ISSUED FOR ADDENDUM NO. 3
DATE: 02-15-2024
BY: OAM
STATUS: REVISED

SITE PLAN - 2
 OF:
BULKY WASTE & TRANSFER STATION IMPROVEMENTS
 LEACH HILL ROAD
 CASCO, MAINE 04015
 FOR:
TOWNS OF CASCO & NAPLES
 CASCO - 635 MEADOW ROAD
 NAPLES, P.O. BOX 1757
 NAPLES, ME 04055

SHEET C-104

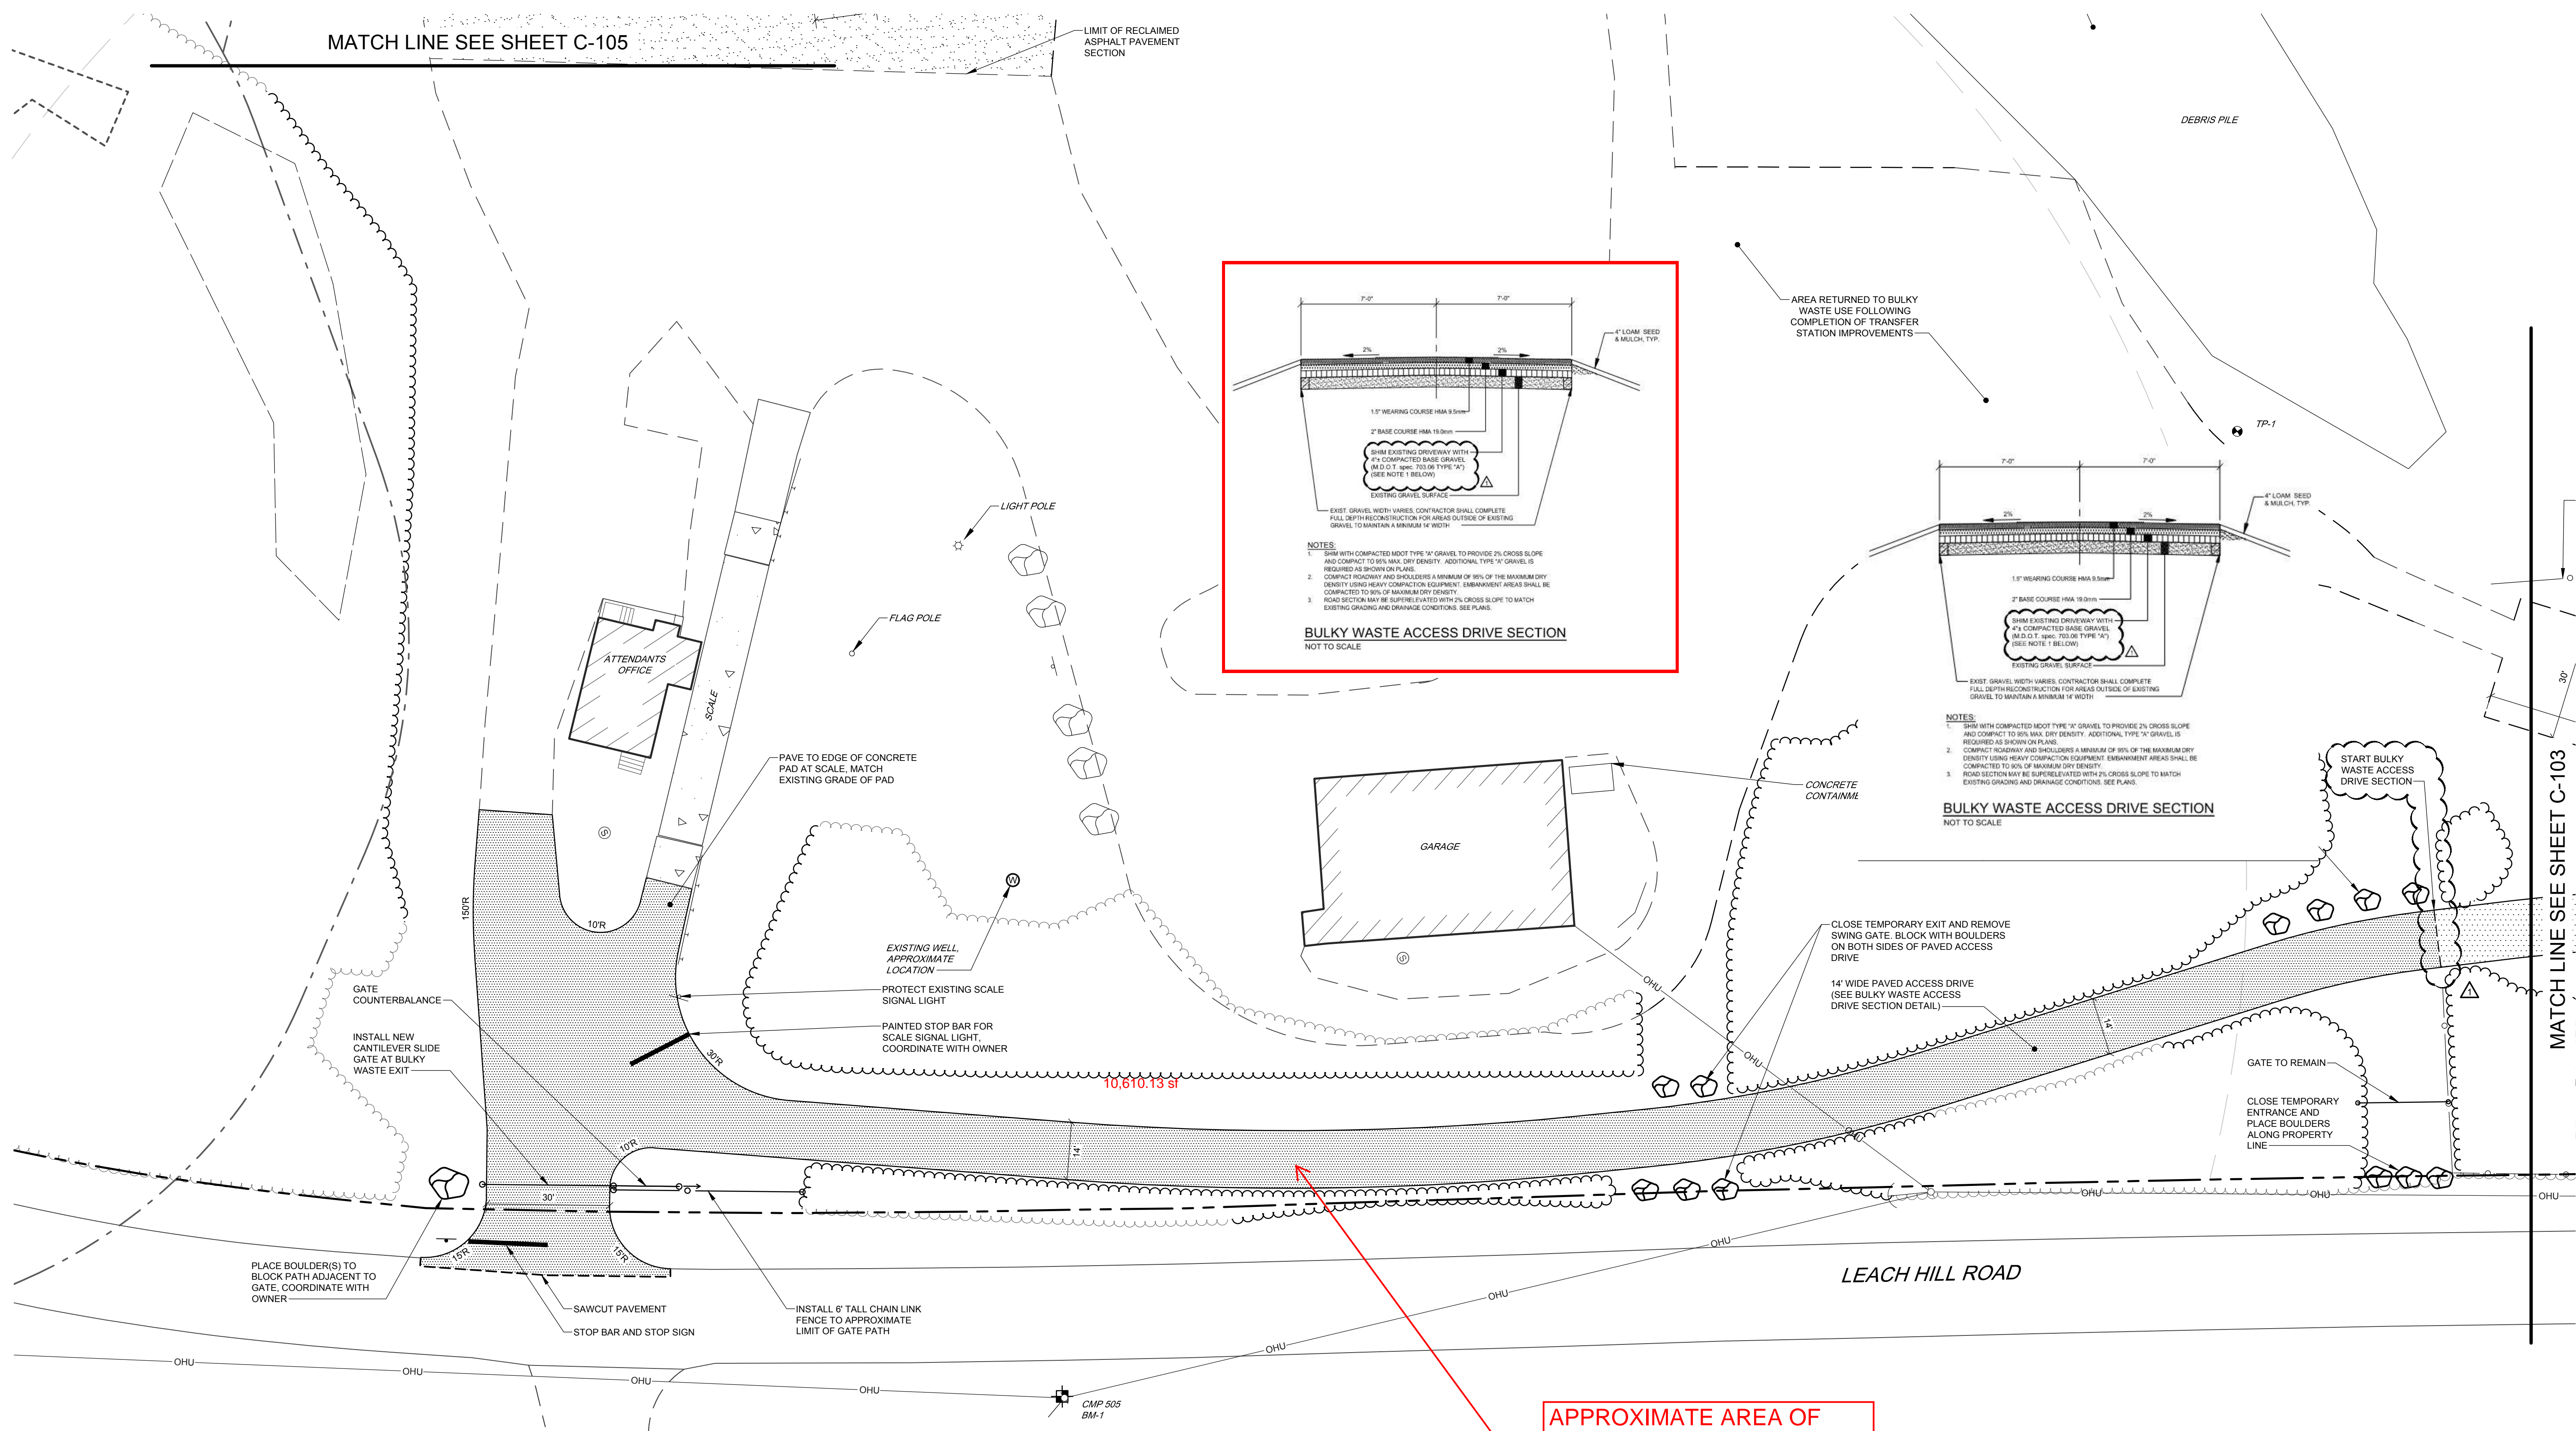
LIMIT OF RECLAIMED ASPHALT PAVEMENT SECTION

APPROXIMATE AREA OF PAVING = 11,000 S.F.
SEE DETAIL PLAN SHEET C-503
